# Access Compliance Report

## Public Rights-of-Way

### (Curb Ramps)

Intersection ID: 52918	Main Street: HOOVER_CREEK_BV	Cross Street: STEELE_CREEK_RD	Location: NW
ADA ID: 078B287A30F5	Ramp Type: Perp	Initial Pass/Fail: Fail	Overall Compliance: No
Severity Score: 10			
Codes/Mitigation Info/Possible Solution		Field Measurements/Component Compliance

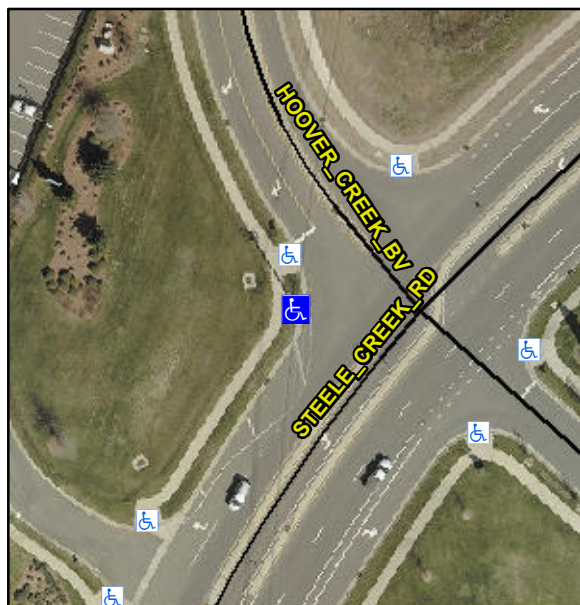
**Not Found, R304.5.1, R304.5.3**

Compliance	Description	Data	Compliance	Description	Data
N/A	Ramp Length (in)	102.0	Yes	Ramp Slope (%)	7.2
No	Ramp Width (in)	46.0	No	Ramp XSlope (%)	4.0
N/A	Flare Type LT	N/A	N/A	Flare Type RT	N/A
N/A	Flare Slope LT (%)	N/A	N/A	Flare Slope RT (%)	N/A
N/A	Flare Traversable LT?	N/A	N/A	Flare Traversable RT?	N/A
N/A	Landing Length (in)	N/A	N/A	DWS Provided?	N/A
N/A	Landing Width (in)	N/A	N/A	DWS Contrast?	N/A
N/A	Landing Slope (%)	N/A	N/A	DWS Length (in)	N/A
N/A	Landing X Slope (%)	N/A	N/A	DWS Full Width?	N/A
N/A	Landing Curb? (Y/N)	N/A	N/A	DWS Offset (in)	N/A
N/A	Shared Landing?	N/A			
N/A	Gutter Ponding?	N/A	N/A	Gutter Slope (%)	N/A
N/A	Gutter Lip Ht (in)	N/A	N/A	Gutter X Slope (%)	N/A
N/A	Painted X Walk1?	No	N/A	Painted X Walk2?	N/A
	X Walk 1 Direction	To SE		X Walk 2 Direction	N/A
N/A	X Walk 1 Width (in)	N/A	N/A	X Walk 2 Width (in)	N/A
	X Walk 1 Slope (%)	4.1		X Walk 2 Slope (%)	N/A
	X Walk 1 X Slope (%)	1.6		X Walk 2 X Slope (%)	N/A

**Remove & Replace Entire Ramp.**
